ILLINOIS POWER COMPANY

September 28, 1984

Subject: Clinton Power Station Unit 1  
DRAFT Technical Specifications

Illinois Power is enclosing a revised mark-up of the Clinton Power Station "DRAFT" Technical Specifications for your review. The changes indicated in the enclosure are provided as a result of our review of plant specific design information, information contained in the Clinton Power Station Final Safety Analysis Report, requirements/commitments delineated in the Clinton Power Station Safety Evaluation Report (NUREG-0853) through Supplement No. 3, and the Technical Specifications of recent licensees.

Figure 3.1.5-1 WEIGHT PERCENT SODIUM PENTABORATE SOLUTION AS A FUNTION OF NET TANK VOLUME

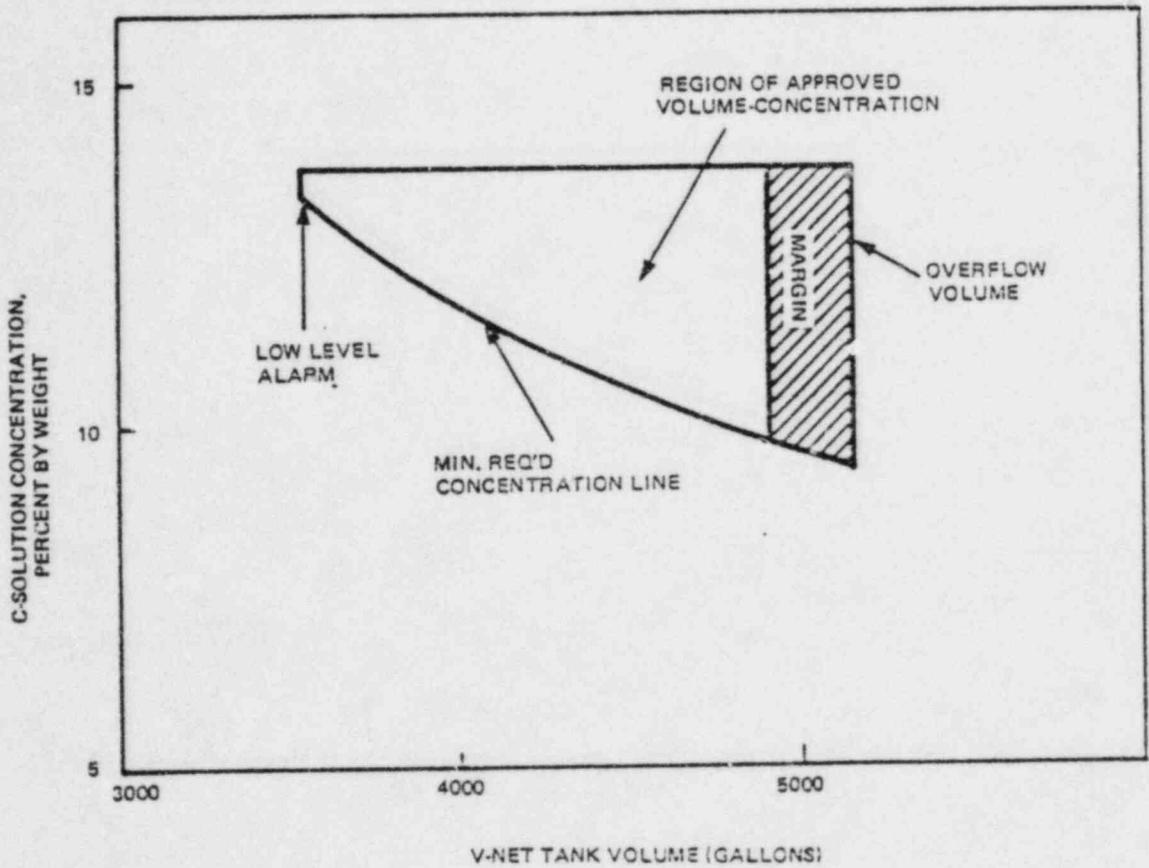
1. The temperature of the sodium pentaborate solution <sup>in the storage tank</sup> is ~~within the~~ <sup>greater than</sup> ~~limits of Figure 3.1.5-1.~~ CFS  
or equal to 70°F.
2. The available volume of sodium pentaborate solution is <sup>within</sup> ~~greater than~~ ~~or equal to 3542 gallons.~~ CFS  
the limits of Figure 3.1.5-1.
3. The heat tracing circuit is OPERABLE by determining the temperature of the (pump suction piping) to be greater than or equal to (70)°F.

\*This test shall also be performed anytime water or boron is added to the solution or when the solution temperature drops below ~~the limit of Figure 3.1.5-1.~~ <sup>70°F.</sup> CPS

DELETE AND  
INSERT FOLLOWING  
PAGE

AVERAGE PLANAR EXPOSURE (MWd/ft)  
 Maximum Average Planar Linear Heat  
 Generation Rate (MAPLHGR) Versus  
 Average Planar Exposure  
 Initial Core Fuel Types - High Enrichment  
 Figure 3.2.1-1

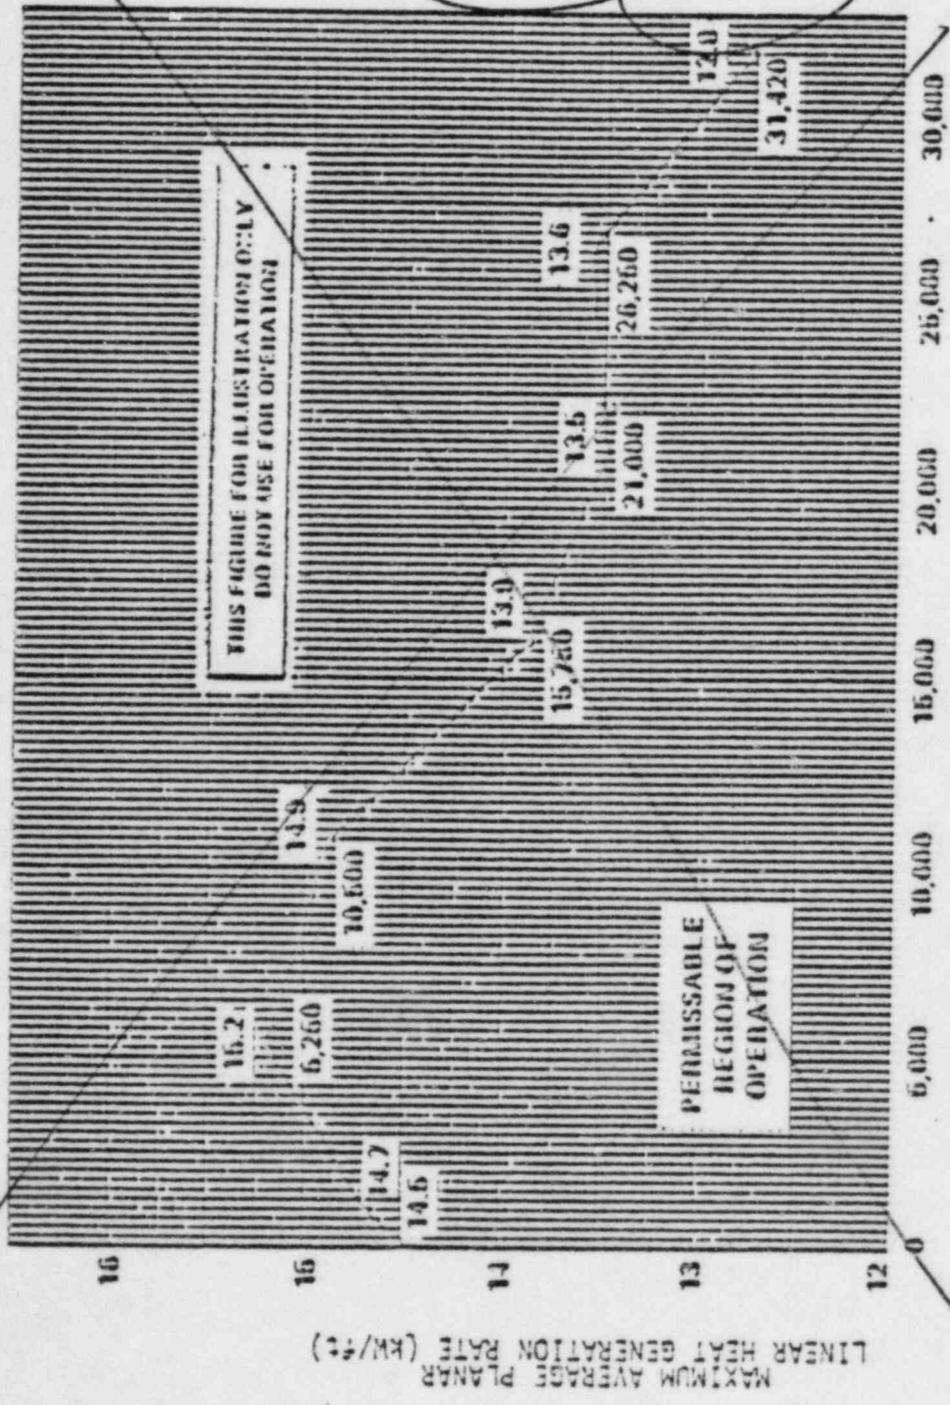
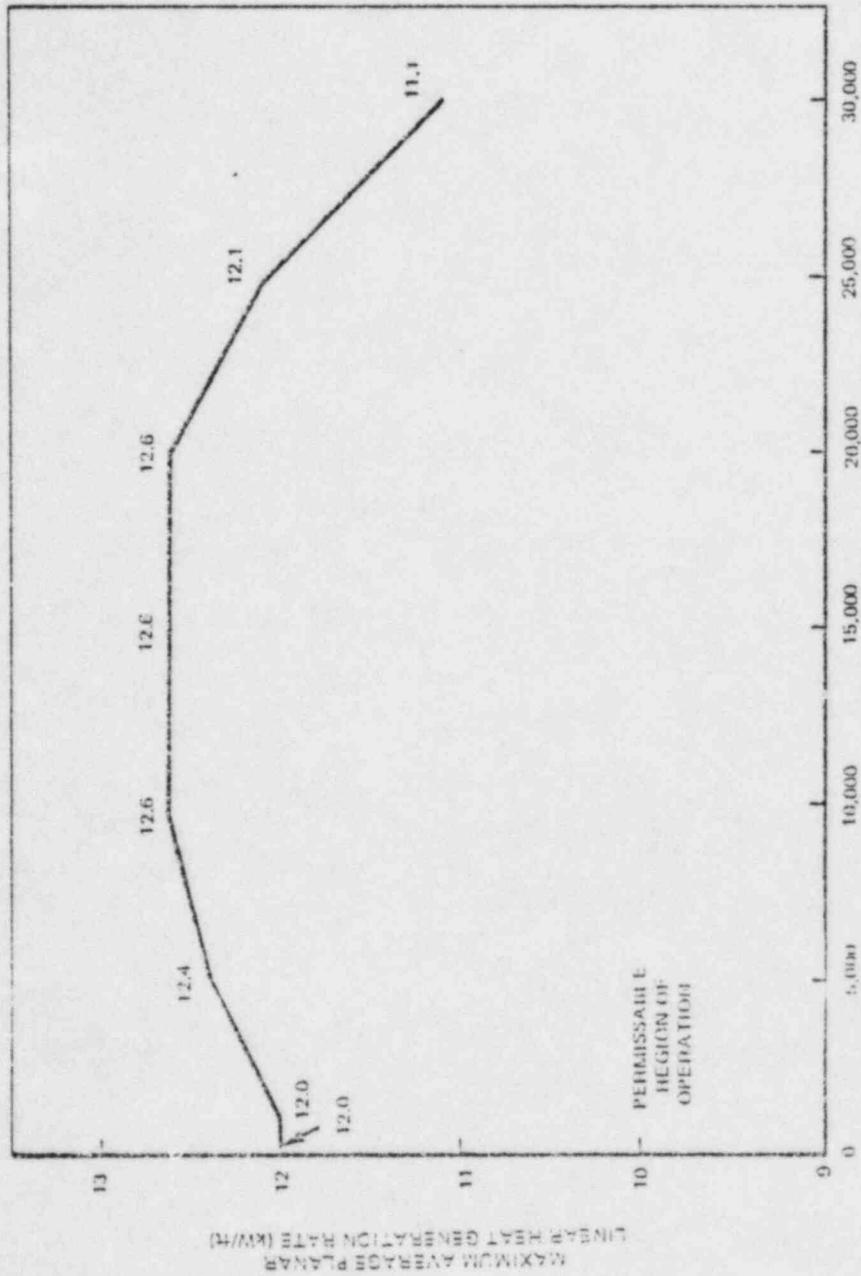
DELETE  
AND INSERT  
FOLLOWING  
PAGE

Maximum Average Planar Linear Heat Generation Rate (MAPLHGR) Versus Average Planar Exposures Initial Core Fuel Types Medium Enrichment  
Figure 3.2.1-2

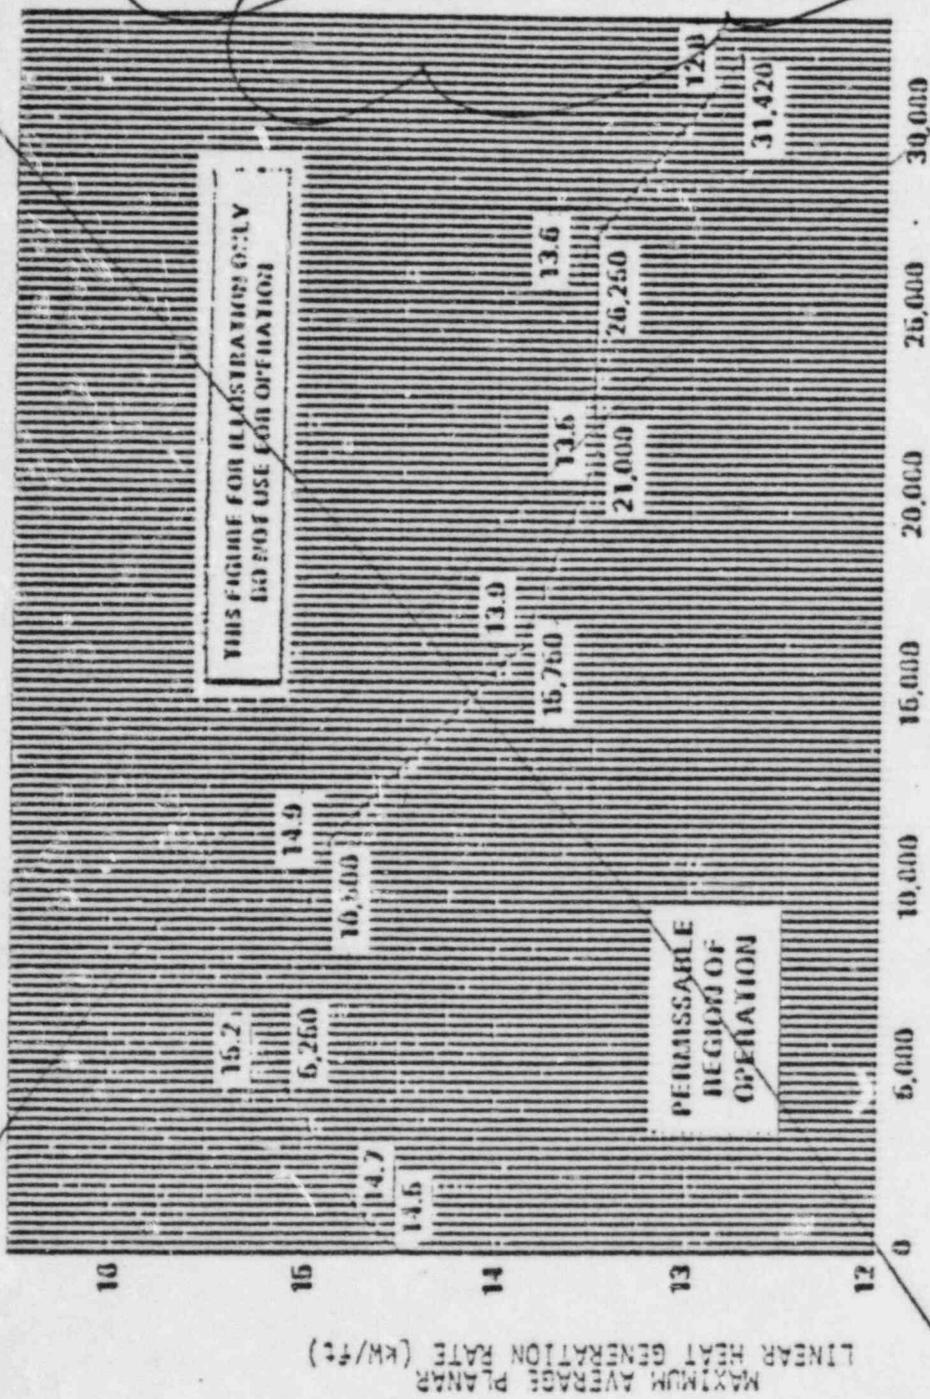
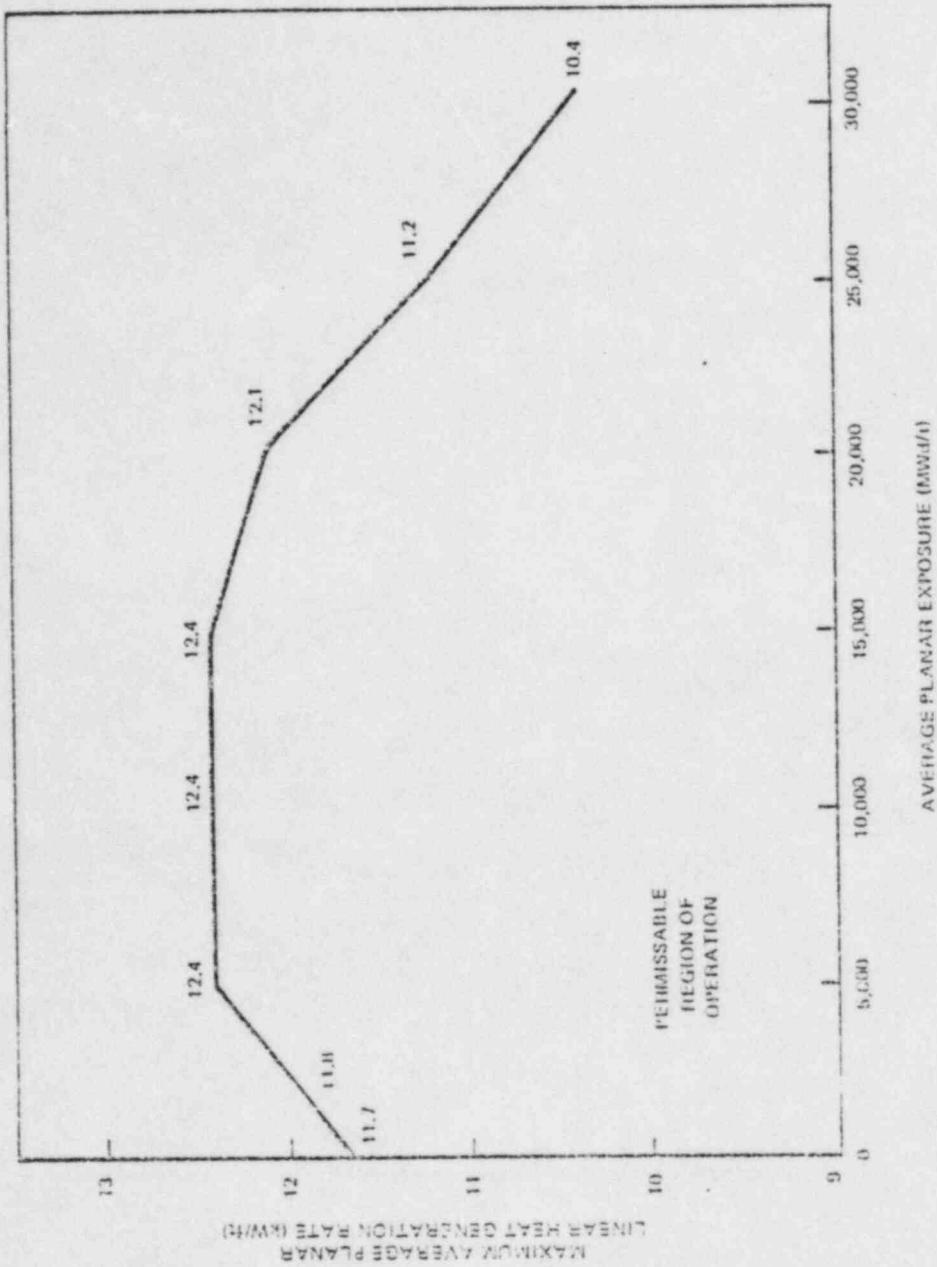
DELETE AND  
INSERT - FOLLOWING  
PAGE

Maximum Average Planar Linear Heat Generation Rate (MAPLHGR) Versus Average Plaster Exposure  
 Initial Core Fuel Types Natural Enrichment  
 Figure 3.2.1-3

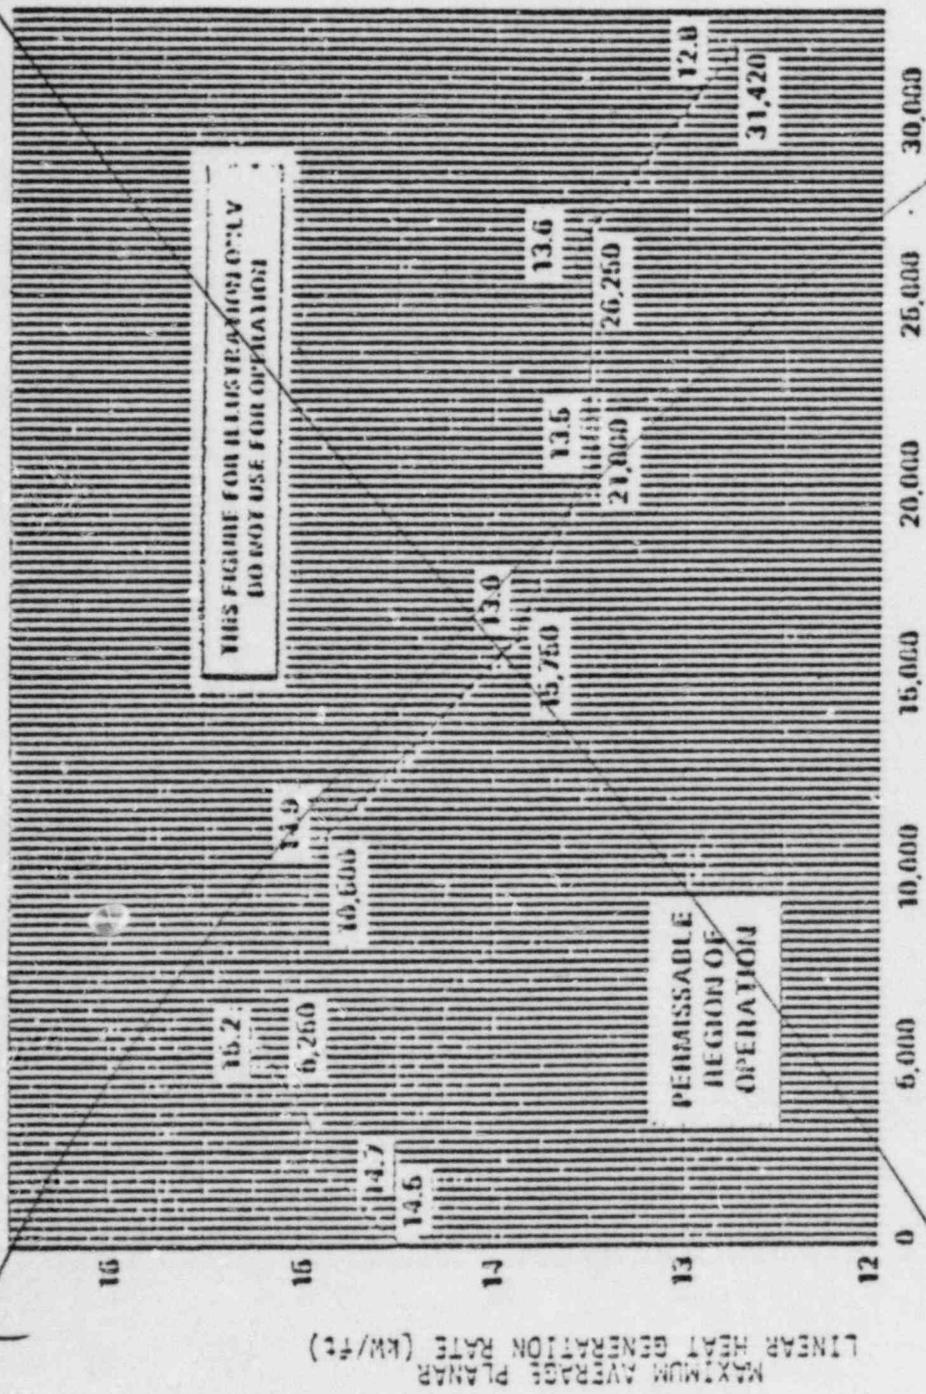
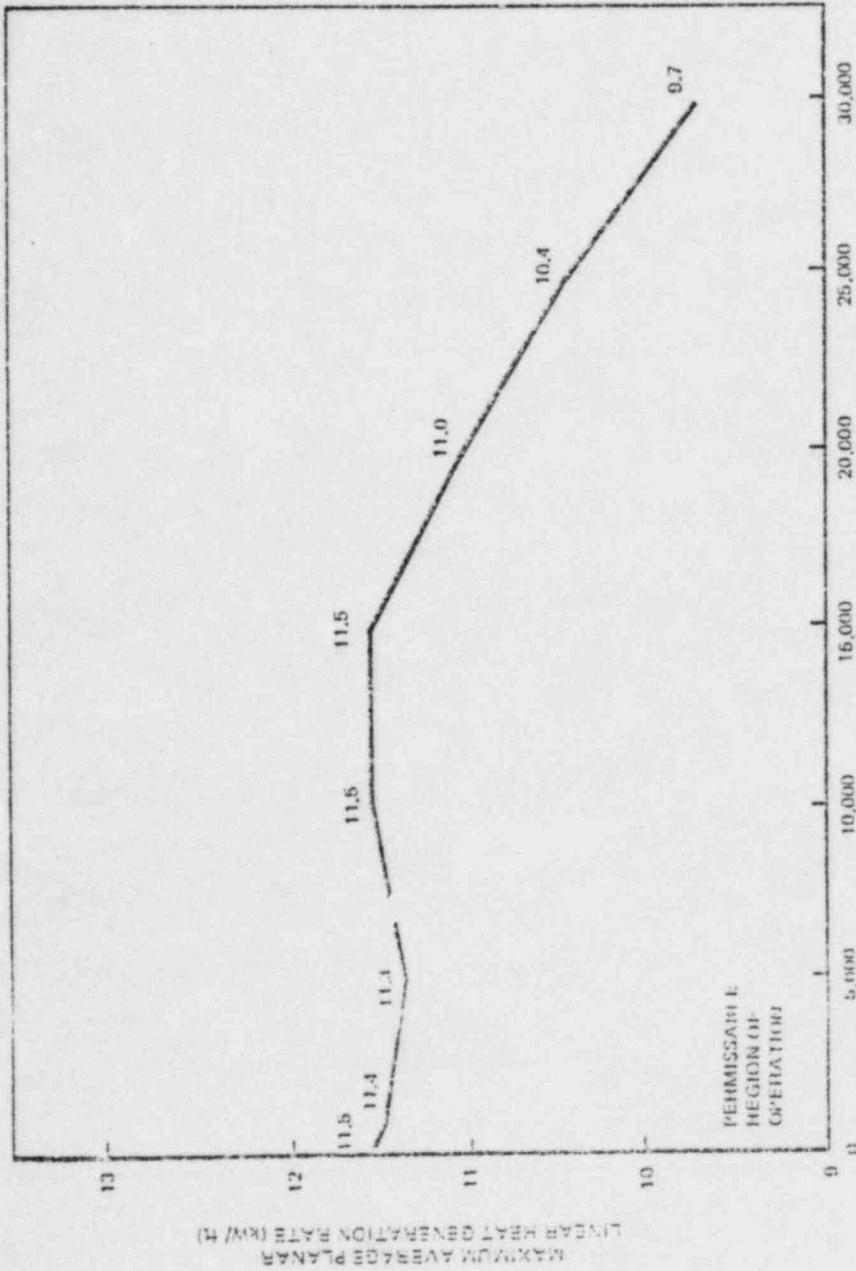
DELETE AND  
INSERT FOLLOWING  
PAGE
